Planning Commission Agenda

Site Plan Review

Site: 27700 Southfield Road
Applicant: Akiva Investments, LLC
Plan Date: October 21, 2024
Zoning: VC Village Center District
Parcel ID: 24-13-303-021
Proposal: Mixed Use: Residential & Commercial

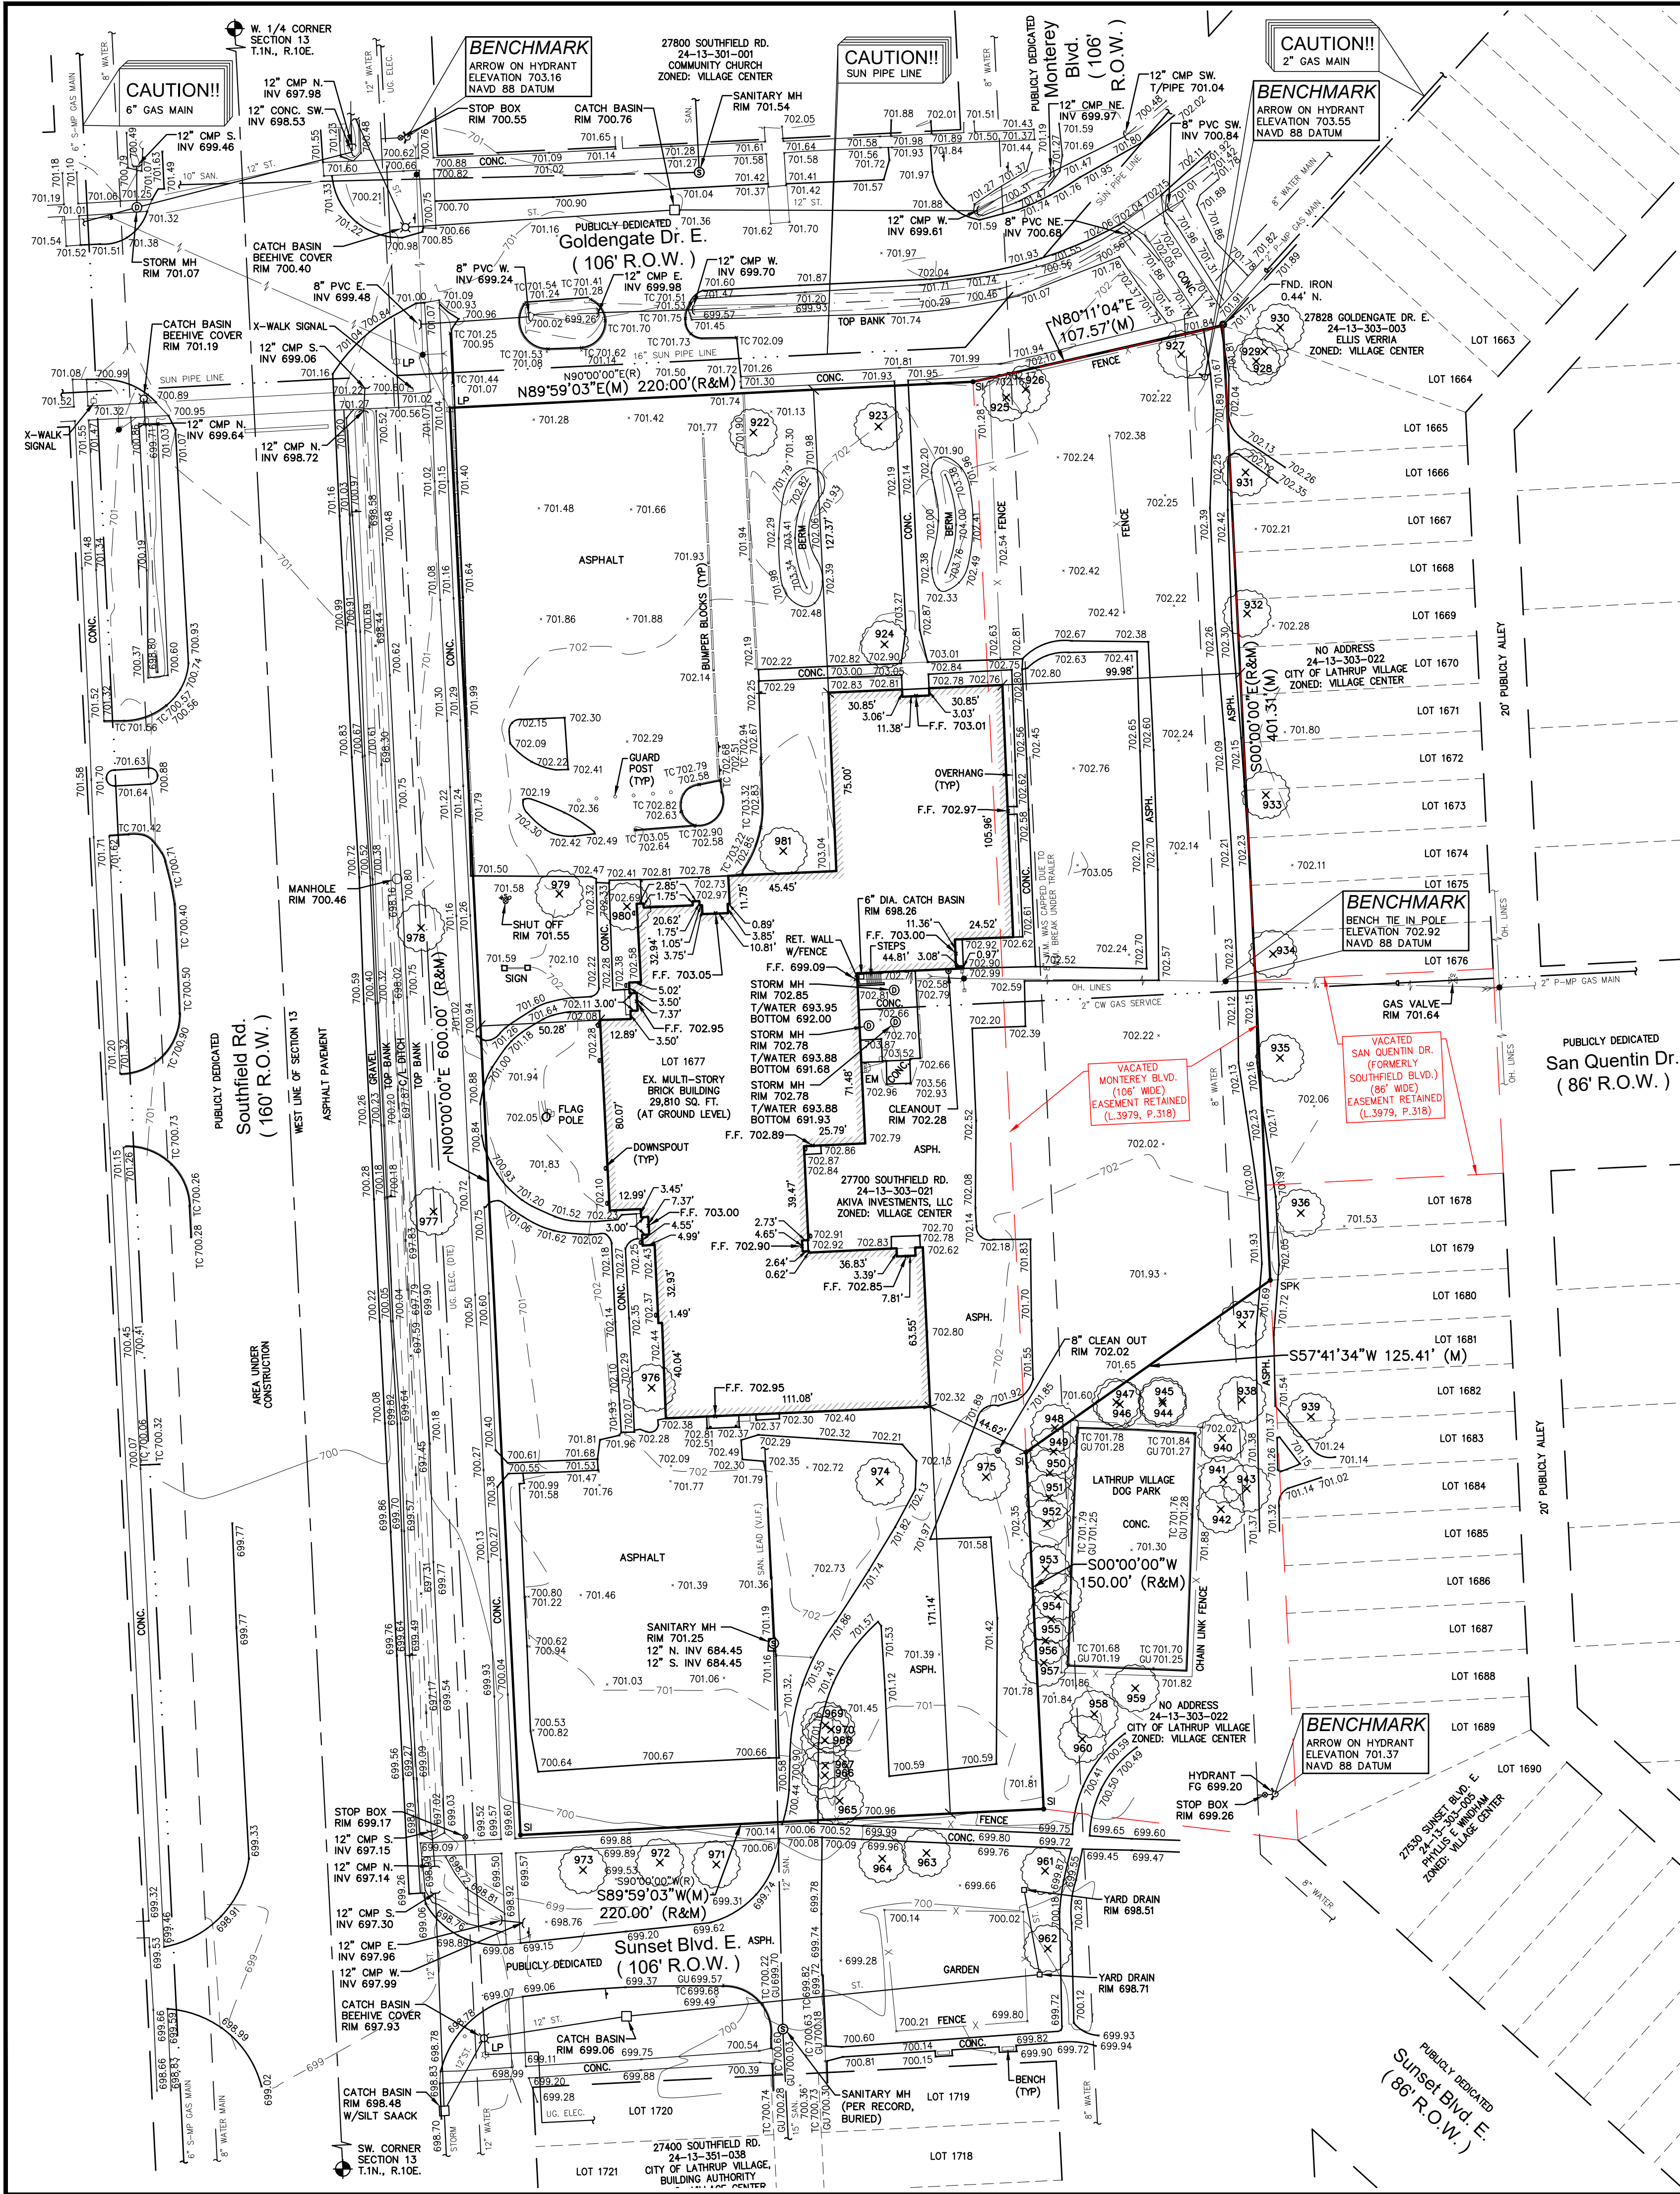
4. The ordinance allows some flexibility with respect to parking, allowing the Planning Commission to waive up to 25% of the required parking in the VC district. The applicant proposes 1.5 parking spaces, or 218 spaces for the 145 dwellings, based on their market research and past residential development experience in several surrounding communities. The site proposes 200 spaces on site and 18 parking spaces off-site, within the Golden Gate Drive E. right-of-way to the north. **The Planning Commission may consider a waiver of up to 72 spaces (25% of the required 290 spaces); the construction of 18 on-street spaces requires approval and agreement from the City following approval by the Planning Commission. The applicant should correct the table on sheet SP03, which says there are 128 units and the requirement is one space per unit.**

Any additional parking demand generated by the central amenities within the existing historic building (2 stories and 12,949 sq. ft.) will be addressed by parking agreements with adjacent properties to the north and west. According to the applicant, the site will also implement a valet parking service. Sheet SP 101 (Architectural Site Plan) provides a breakdown of the number of one- and two-bedroom units that comprise the buildings, 83 and 62 units respectively. We note the sheet SP03 incorrectly notes the number of units as 128; this should be corrected.

201.03 WEST ELEVATION
A.201 NOT TO SCALE

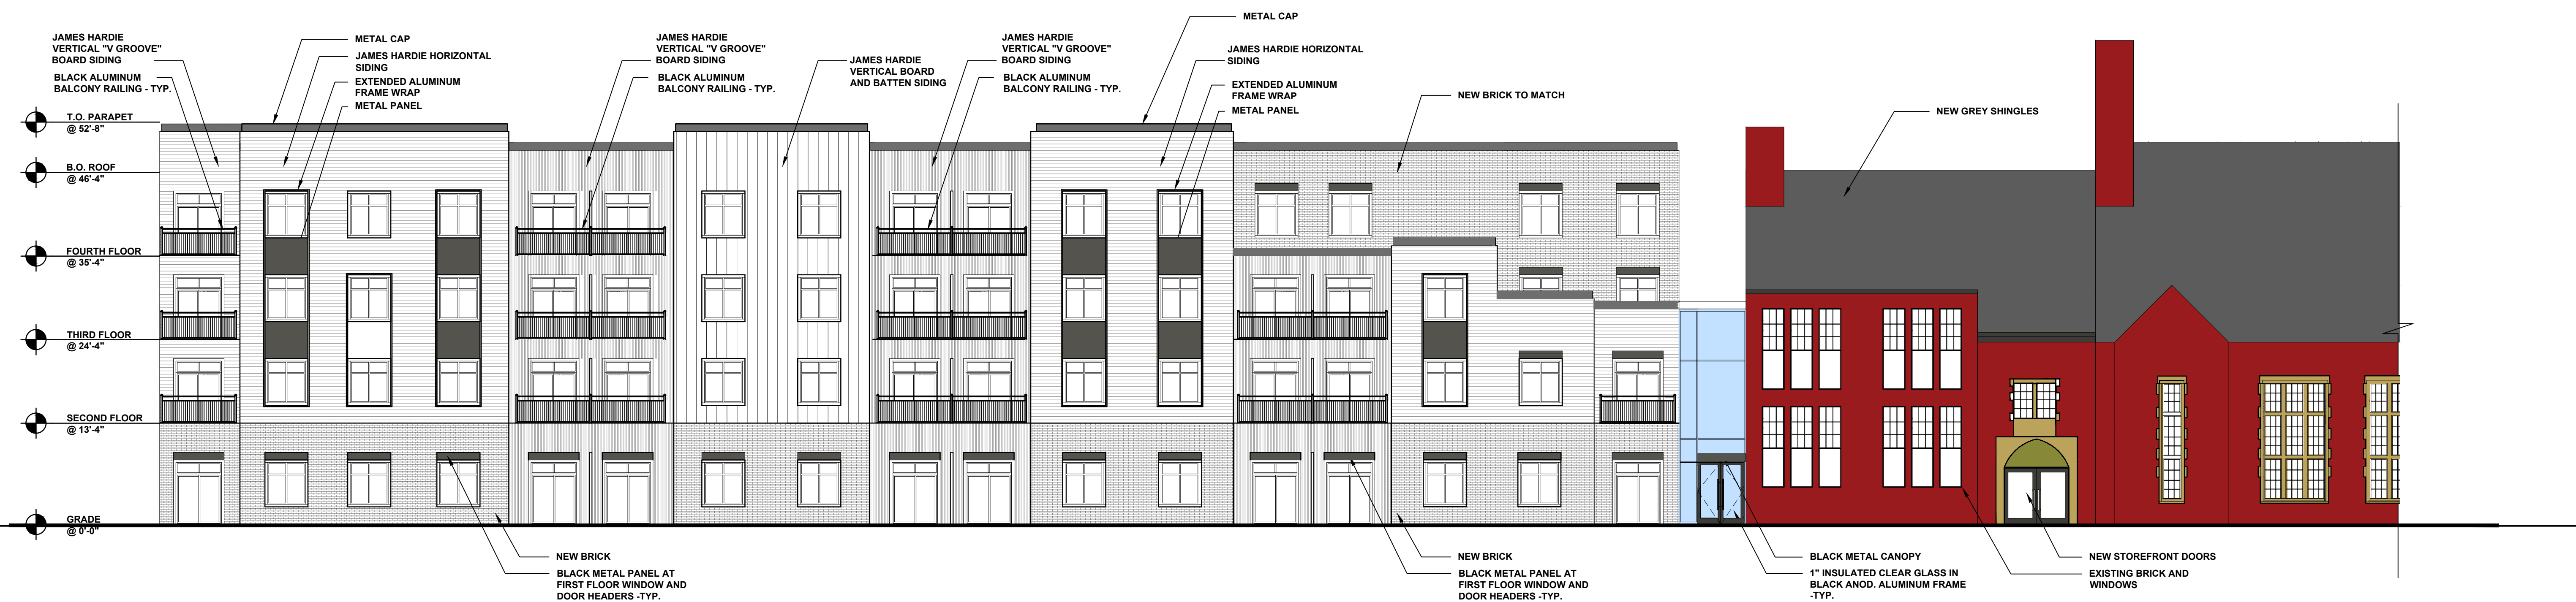
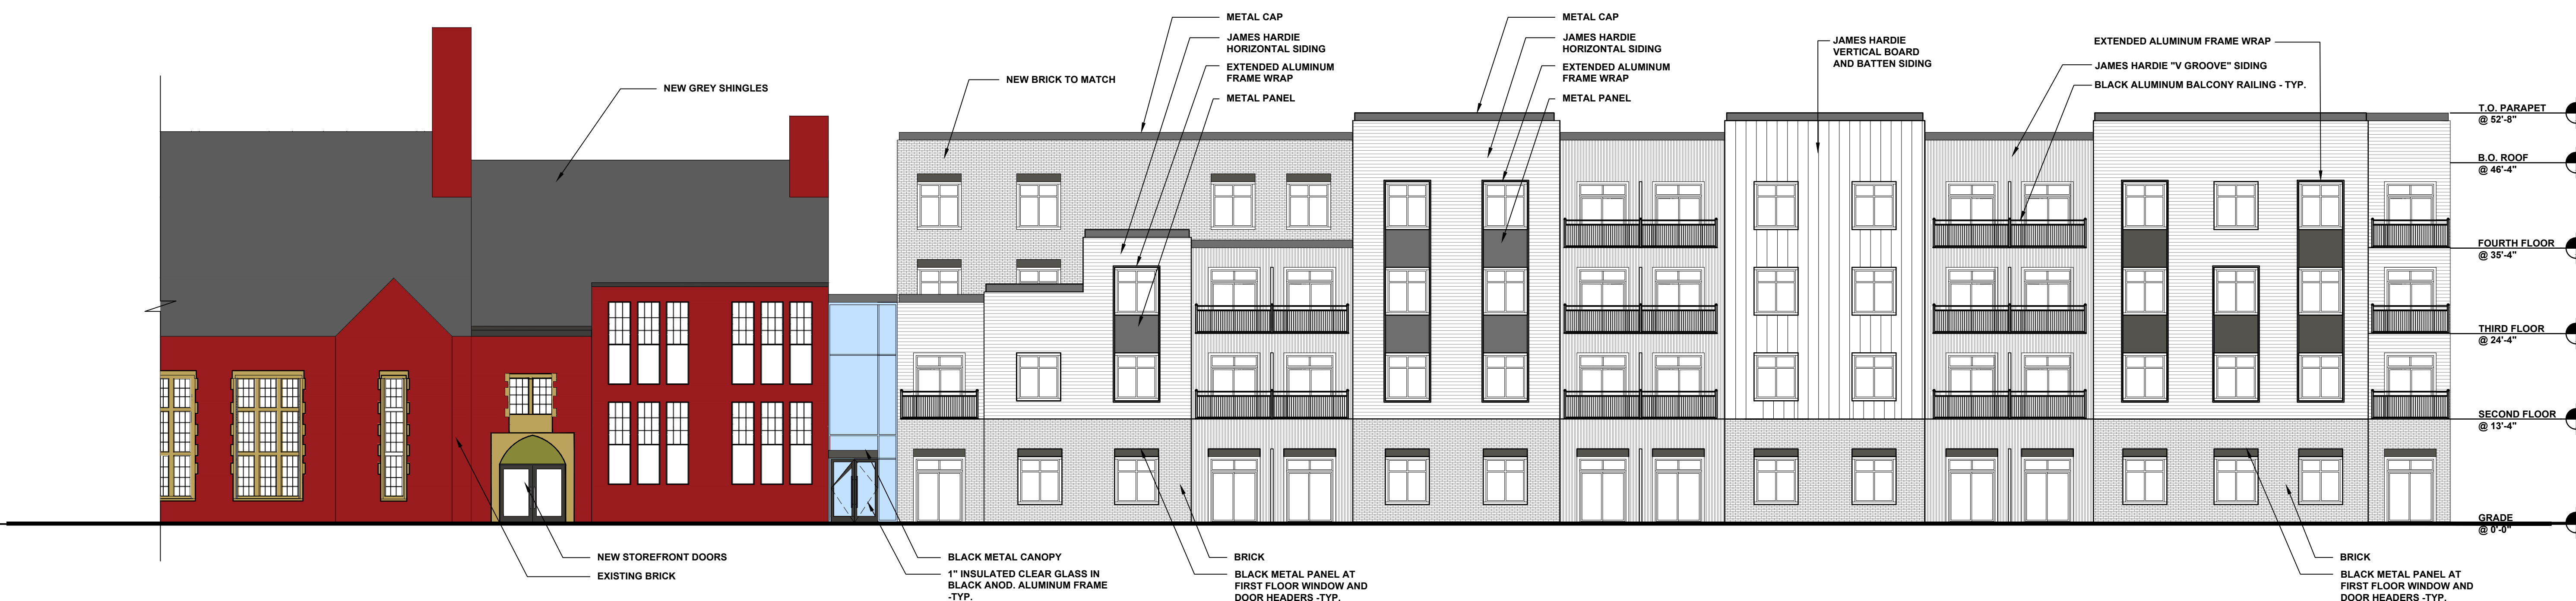
6. **Base Level (ground floor) frontage base types are required to consist of either an arcade or storefront, as shown in the image at right, or residential, which is subject to consideration and approval by the Planning Commission.** The proposed buildings consist of multi-family dwelling units with windows and private patio doors that reflect much of the intent of the standards of this section of the ordinance. Base level material consists of brick.

The middle sections of the buildings are depicted by a change in material from brick to sections of vertical and horizontal Hardie Board. Four segments along the Southfield Road frontage consist of balconies with black metal railings. Vertical metal siding has been removed.

The elevations and renderings show a minor metal cap as the defining feature of the top of the buildings which satisfies the noticeable roof edge requirement.
